City of Detroit Inter-Departmental Communication

Petition No. 410

Request to Outright Vacate a Portion of the North/South Alley in the Block Bound

by Clay, Cameron, Euclid, and the Carysler Freeway

REQUEST TO OUTRIGHT VACATE SEWER A PORTION OF THE NORTH/SOUTH PUBLIC ALLEY 19.25 FT. WD. IN THE BLOCK BOUND BY CLAY, CAMERON, EUCLID AVE. AND CHRYSLER FREEWAY CITY OF DETROIT
CITY ENGINEERING DEPARTMENT
SURVEY BUREAU

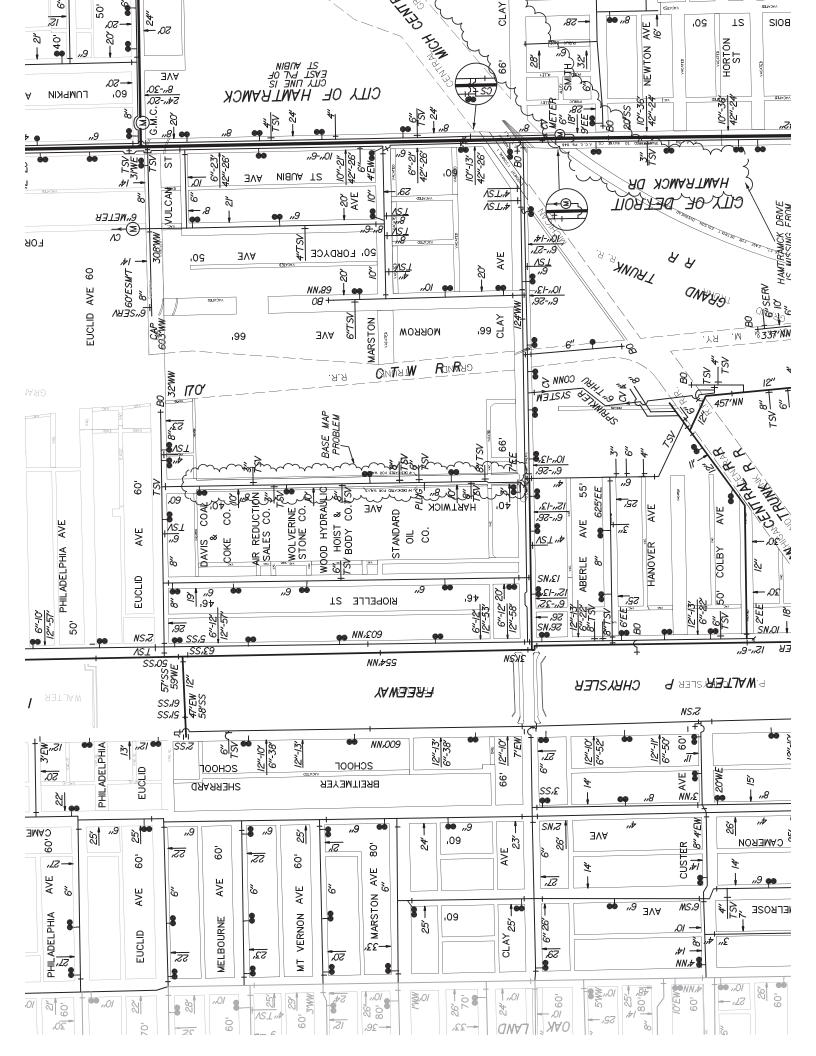
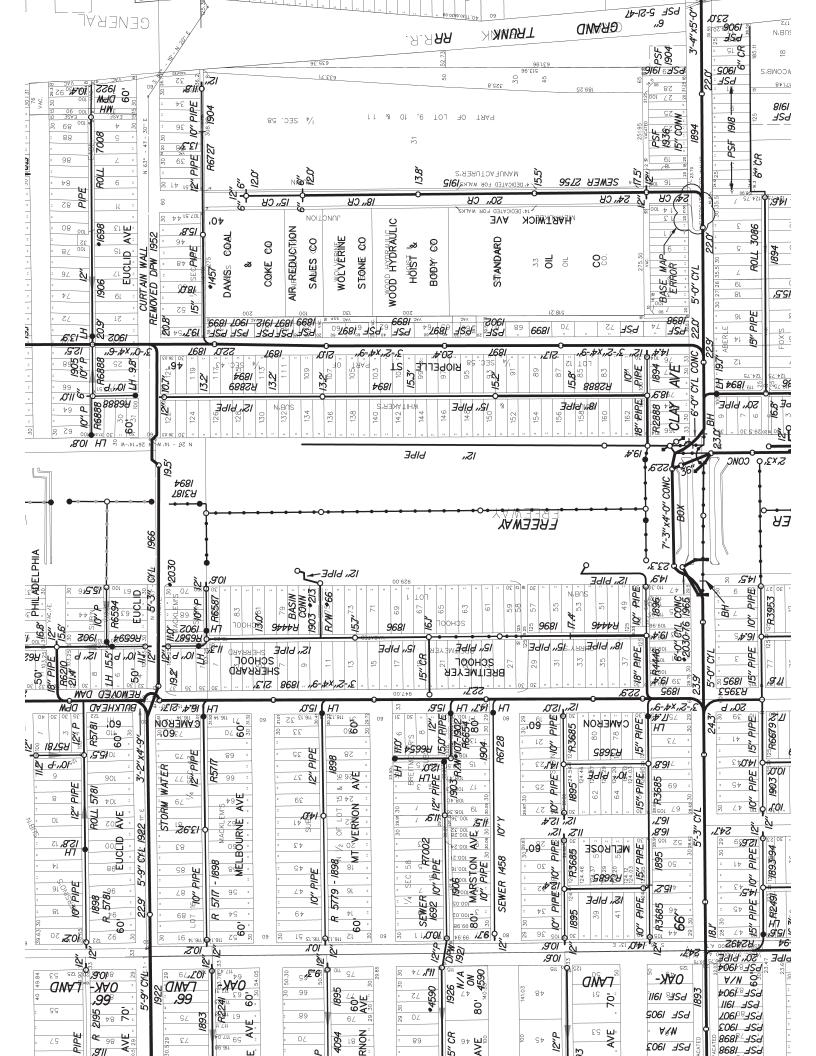
Our records indicate that there is a sewer in the alley. DWSD objects to the outright vacation of a portion of the alley. However, DWSD has no objections if the petitioner agrees to relocate the sewers in accordance with the attached provisions for relocation at no cost to DWSD.

Provided that the petitioner (Petition 410) shall design and construct proposed lateral sewer and make the connections to the existing public sewers as required by the Detroit Water and Sewerage Department (DWSD) prior to construction of the proposed sewers;

Provided, that the plans for the lateral sewers shall be prepared by a registered engineer; and further

Provided, that DWSD be and is hereby authorized to review the drawings for the proposed lateral sewers and to issue permits for the construction of the lateral sewers, and further;

Provided, that the entire work is to be performed in accordance with DWSD specifications and constructed under the inspection and approval of DWSD; and further;

Provided that the entire cost of the proposed lateral sewer construction, including inspection, survey and engineering shall be borne by the petitioner; and further;

Provided that the petitioner shall provide DWSD with as -built drawings on the proposed lateral sewers and further;

Provided that the petitioner shall provide a one (1) year warranty for the proposed lateral sewer; and further

Provided that upon satisfactory completion the lateral sewers shall become city property, and part of the City system.
